City of San Antonio
TRANSPORTATION AND CAPITAL IMPROVEMENTS

ADDENDUM NO. 4

PROJECT NAME: **Ray Ellison (Loop 410 to Old Pearsall Road)**

PROJECT NO.: **40-00312**

100 % SUBMITTAL	PROJECT NO.: 8185-00		DATE: 3/24/2015
DRWN. BY: HM	DSGN. BY: HM	CHKD. BY: DT	SHEET NO.: 198

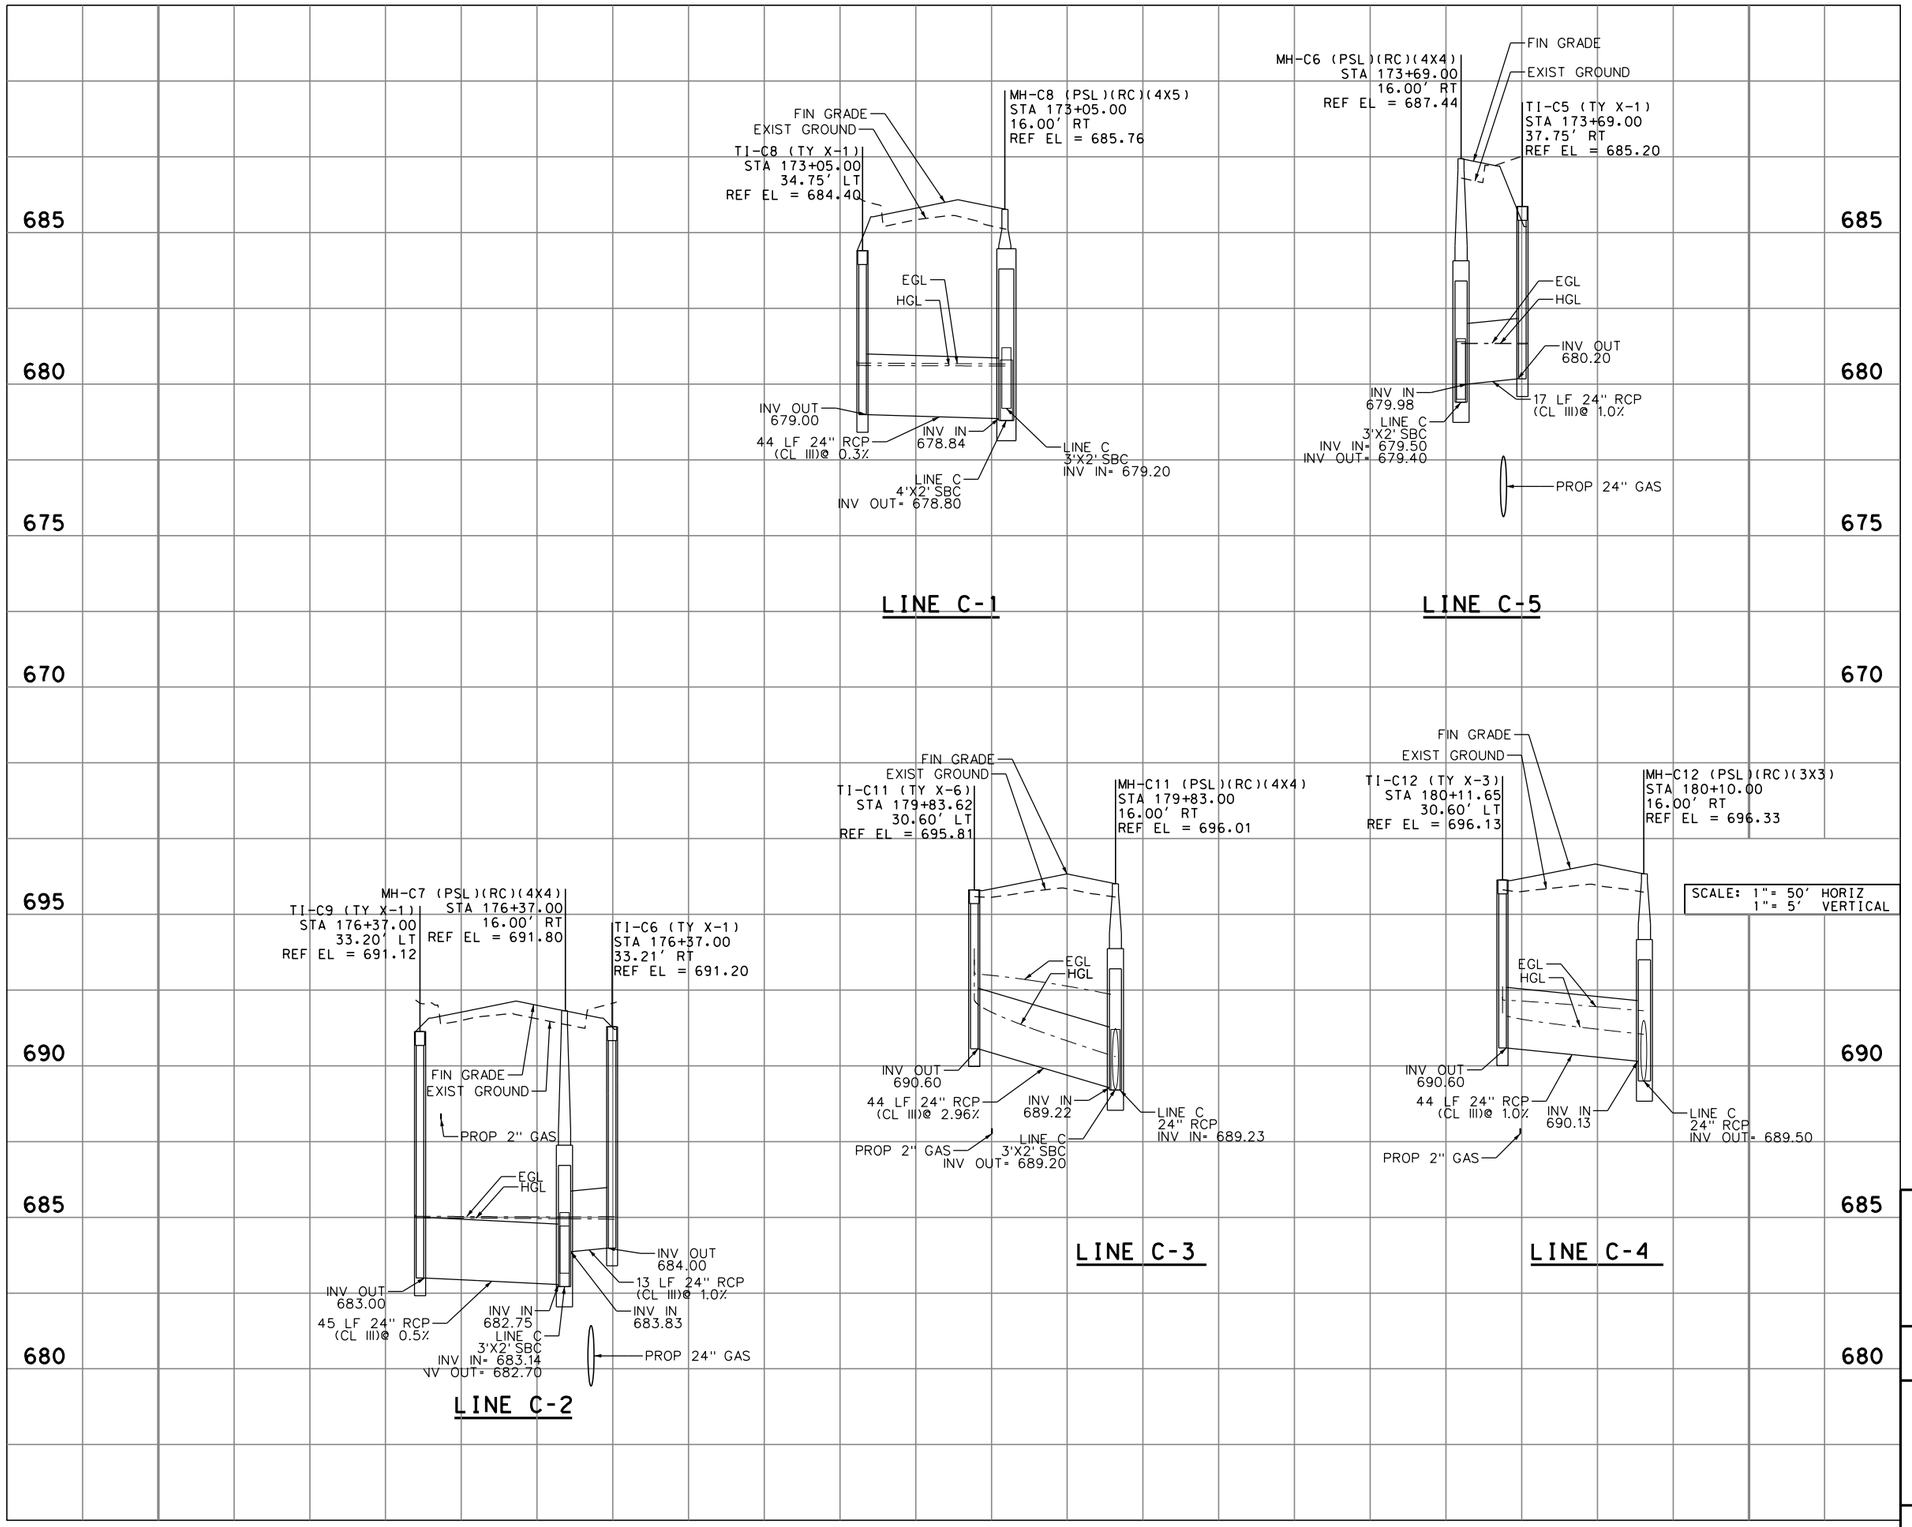
- Replace Sheet 188 “Storm Drain Plan & Profile System C” with Addendum No. 4 Sheet 188 “Storm Drain Plan & Profile System C” Revised ditch.
- Replace Sheet 198 “Storm Drain Laterals” with Addendum No. 4 Sheet 198 “Storm Drain Laterals” Revised line C-1.

100 % SUBMITTAL	PROJECT NO.: 8185-00		DATE: 03-24-15
DRWN. BY: BKM	DSGN. BY: BKM	CHKD. BY: BKM	SHEET NO.: L1.15

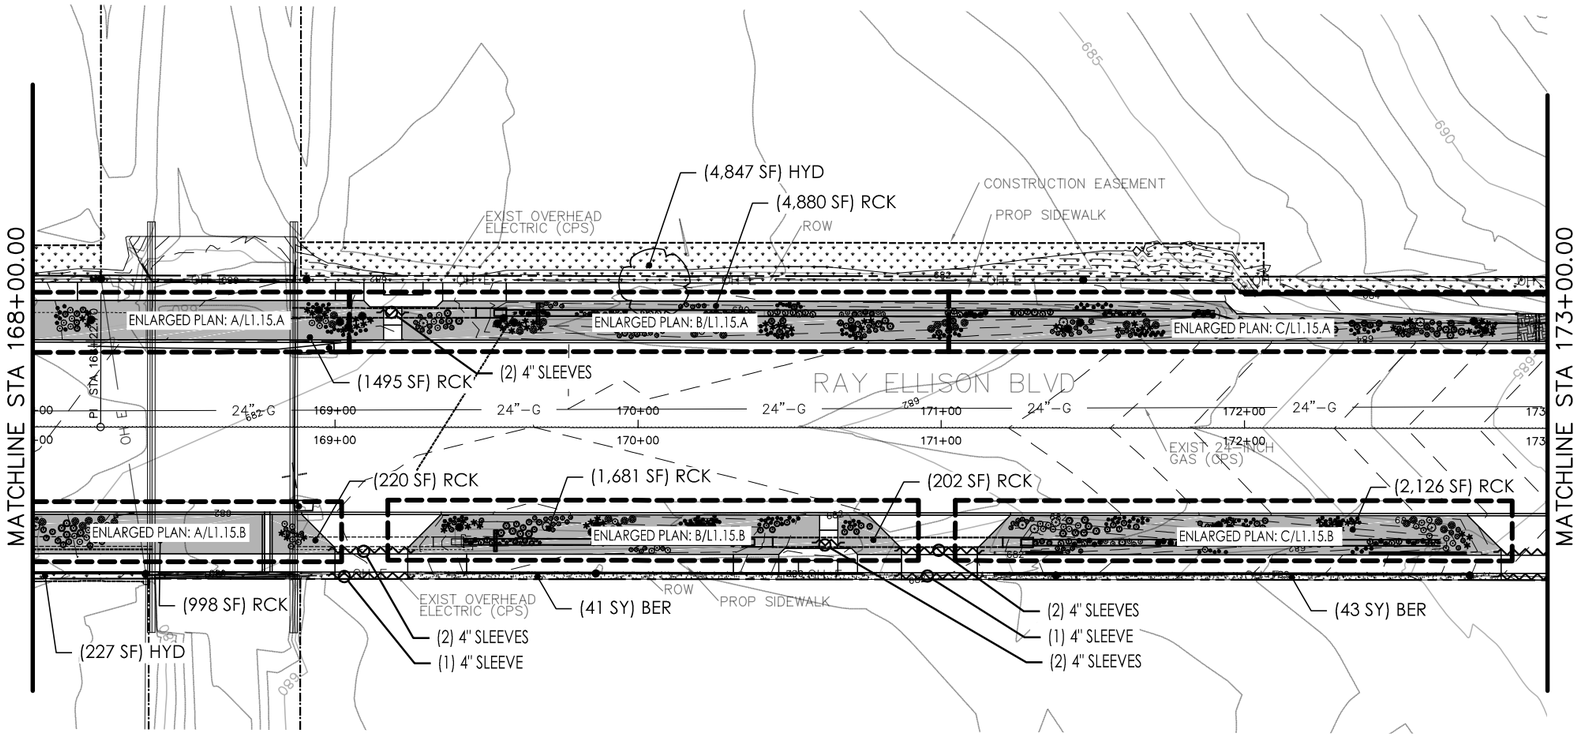
- Replace Sheet L1.15 “Planting Plan” with Addendum No. 4 Sheet L1.15 “Planting Plan” Revised plants.
- Replace Sheet L1.15A “Planting Plan” with Addendum No. 4 Sheet L1.15A “Planting Plan” Revised plants.

100 % SUBMITTAL	PROJECT NO.: 8185-00		DATE: 03-24-15
DRWN. BY: BKM	DSGN. BY: BKM	CHKD. BY: BKM	SHEET NO.: L1.16

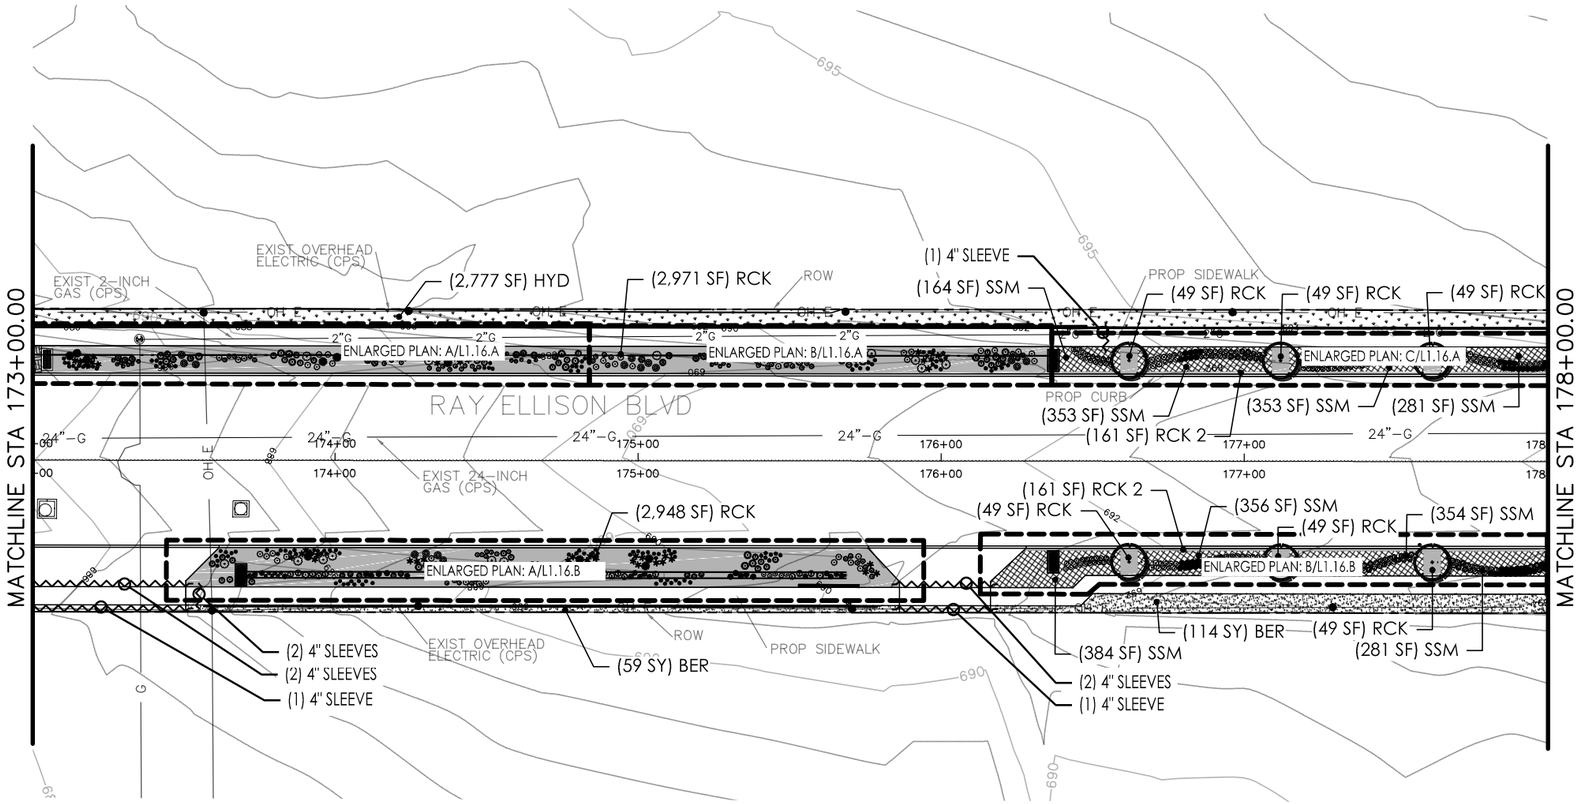
- Replace Sheet L1.16 “Planting Plan” with Addendum No. 4 Sheet L1.16 “Planting Plan” Revised plants.
- Replace Sheet L1.16A “Planting Plan” with Addendum No. 4 Sheet L1.16A “Planting Plan” Revised plants.
